Attn: Field Service Team

Ref: MDW24 Dishwasher "CF" Failure

Low Pressure Switch

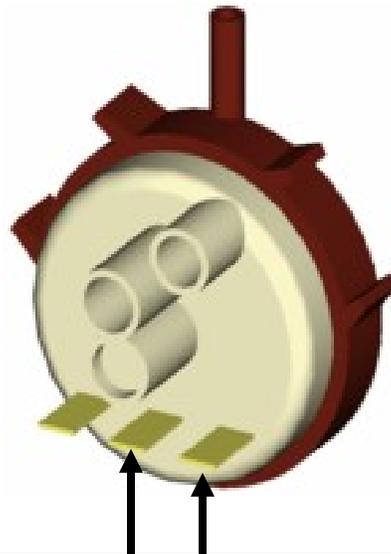
We have discovered that in rare circumstances, the low water pressure switch can also trigger the "CF" indication. If the consumer has already cleaned the filter and you continue to experience the problem, please remove the front/lower access panel and locate pressure switch assembly on the right side. As illustrated below: make sure that all wires leading to the "low pressure switch" are firmly located in place as shown. Take corrective action as is necessary to either repair, re-attach or tighten all wires.

Check these 2 terminals
Normally Open Circuit
Close's when water fills sump
